## **INTERROGATORIES OF ENERGY PROBE RESEARCH FOUNDATION**

**Reference(s):**           **Exhibit D1, Tab 5, Schedule 1 Distribution Fixed Assets**

**PROJECT: E09181 Deerbrook NA502M24 UG Rehab**

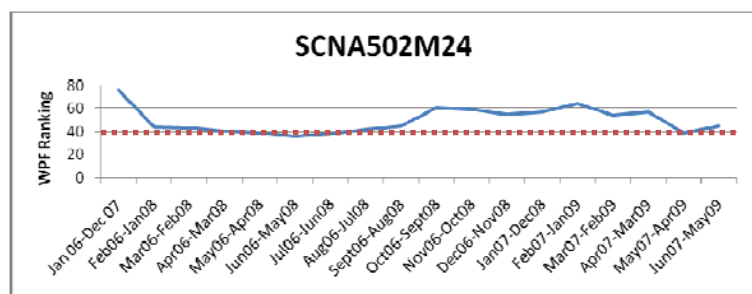
b) In the justification section on page 18, the avoided CMO is shown as 343. Why is the expected improvement in CMO so low?

b) The table used in the justification data on page 18 was incorrect. See the following pages for the correct data.

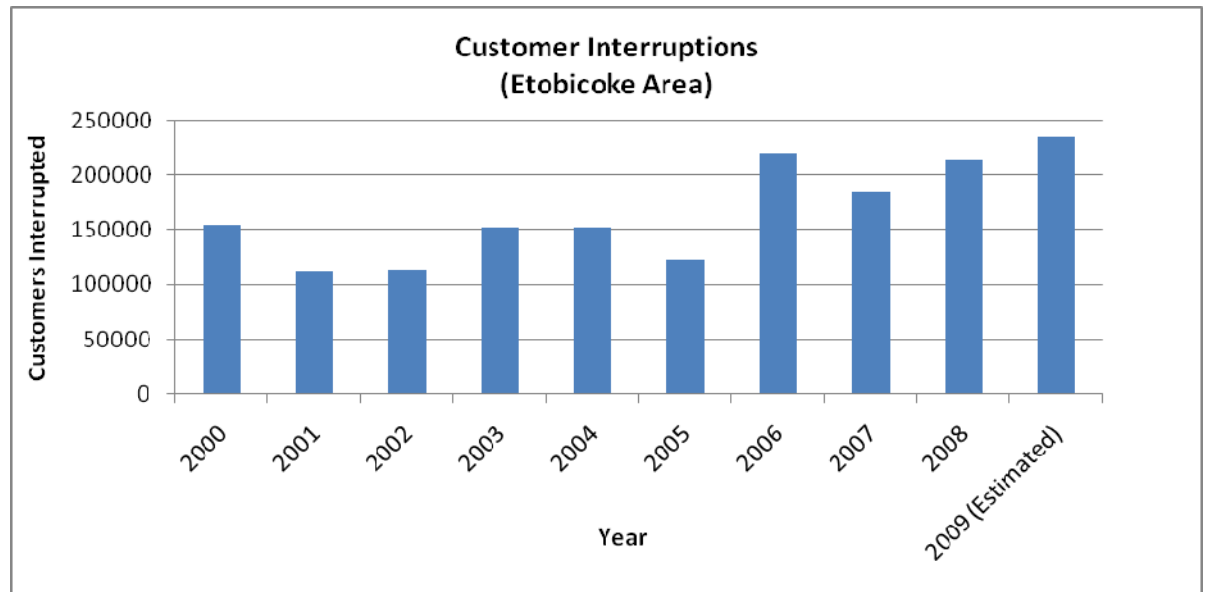
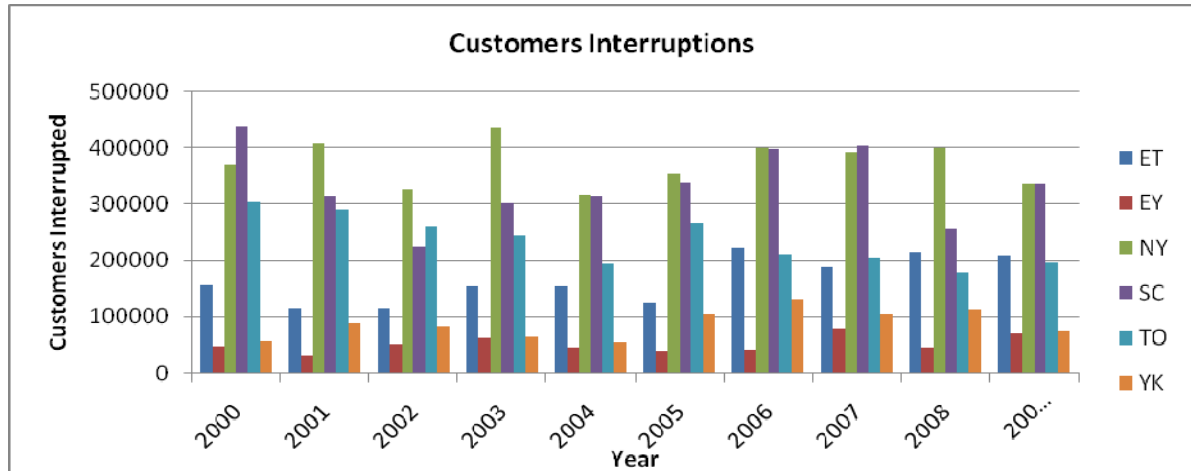
Figure 4 on page 6 shows total customer interruptions in the Etobicoke Area.

- a) Please provide an expanded chart for Etobicoke showing total annual customer interruptions for the 10 years since amalgamation along with comparative charts for other districts/areas within the THESL system? How do these compare with THESL targets for total customer interruptions?
- b) Please provide a chart showing annual SAIDI and SAIFI data for each of the districts and for the total THESL system for the ten years since amalgamation. How do these compare with THESL targets for total customer interruptions?

### Standardized Installation

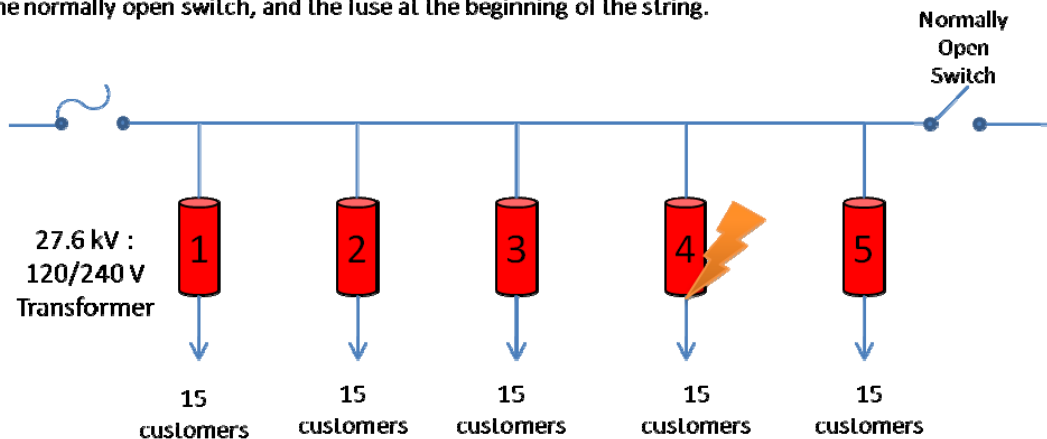
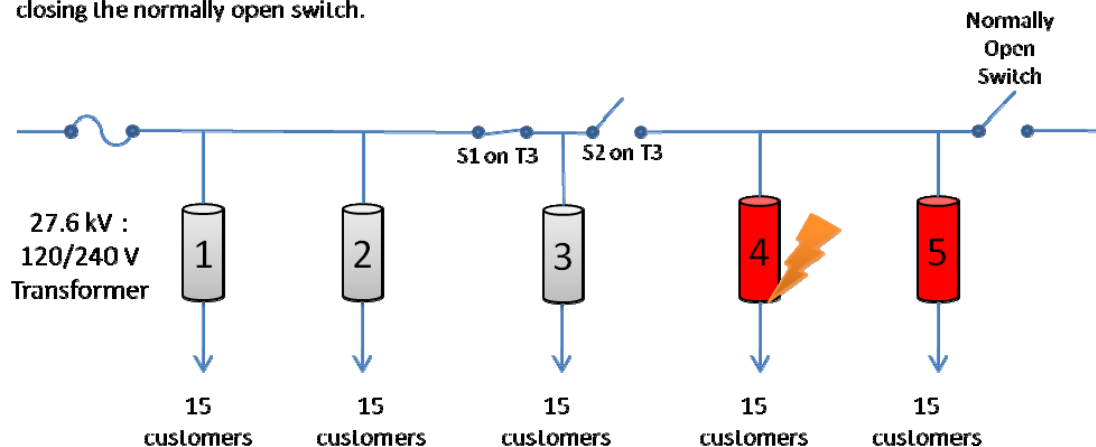
b) If removing the energized primary elbows on a faulted transformer is not an acceptable alternative, is it acceptable to de-energize the loop long enough to remove the elbows, then reenergize to restore power to customers upstream of the faulted transformer?

c) If the proposed sequence in b) is acceptable, please revise the estimates in Table 4 on page 12 to reflect the fact that customers on T1, T2 and T3 in the Legacy Installation illustration on page 11 would only be subject to a switching outage.

10 b) Yes. The example on page 11 is a simplification of the system configuration. Please  
11 see the response to part c) for further explanation.

13 c) See below for a revised example and table.

T3 has been replaced with a standard switchable transformer. When the fault occurs on T4, crews will open S2 on T3, de-energizing T4 and T5, and then pull the elbows on T4. Customers interrupted is 30 (15 customers/transformer x 2 transformers). Power will be restored to T5 by closing the normally open switch.

1       Note that there is still a reduction in the number of customers interrupted. There will  
2       also be an improvement in total customer minutes out, but it will depend heavily on  
3       the switching times and the time required to replace the transformer.
